Access Compliance Report

Public Rights-of-Way

(Curb Ramps)

Intersection ID: 49507	Main Street: OSCEOLA_LN	Cross Street: ANKENY_CT	Location: E
ADA ID: EACAF950416A	Ramp Type: PerpDiag	Initial Pass/Fail: Fail	Overall Compliance: No
Severity Score: 33.75			
Codes/Mitigation Info/Possible Solution		Field Measurements/Component Compliance

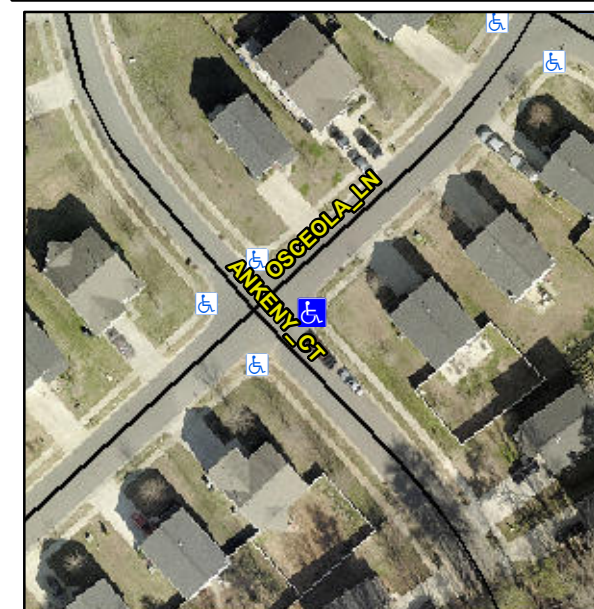
Not Found, R304.5.1, R304.5.3

Compliance	Description	Data	Compliance	Description	Data
N/A	Ramp Length (in)	47.5	Yes	Ramp Slope (%)	7.6
No	Ramp Width (in)	47.5	No	Ramp XSlope (%)	10.5
N/A	Flare Type LT	N/A	N/A	Flare Type RT	N/A
N/A	Flare Slope LT (%)	N/A	N/A	Flare Slope RT (%)	N/A
N/A	Flare Traversable LT?	N/A	N/A	Flare Traversable RT?	N/A
N/A	Landing Length (in)	N/A	N/A	DWS Provided?	N/A
N/A	Landing Width (in)	N/A	N/A	DWS Contrast?	N/A
N/A	Landing Slope (%)	N/A	N/A	DWS Length (in)	N/A
N/A	Landing X Slope (%)	N/A	N/A	DWS Full Width?	N/A
N/A	Landing Curb? (Y/N)	N/A	N/A	DWS Offset (in)	N/A
N/A	Shared Landing?	N/A			
N/A	Gutter Ponding?	N/A	N/A	Gutter Slope (%)	N/A
N/A	Gutter Lip Ht (in)	N/A	N/A	Gutter X Slope (%)	N/A
N/A	Painted X Walk1?	No	N/A	Painted X Walk2?	No
	X Walk 1 Direction	To NW		X Walk 2 Direction	To SW
N/A	X Walk 1 Width (in)	N/A	N/A	X Walk 2 Width (in)	N/A
	X Walk 1 Slope (%)	2.5		X Walk 2 Slope (%)	7.5
	X Walk 1 X Slope (%)	7.3		X Walk 2 X Slope (%)	7.0

Remove & Replace Curb Ramp With Two New Directional Ramps or Equivalent.
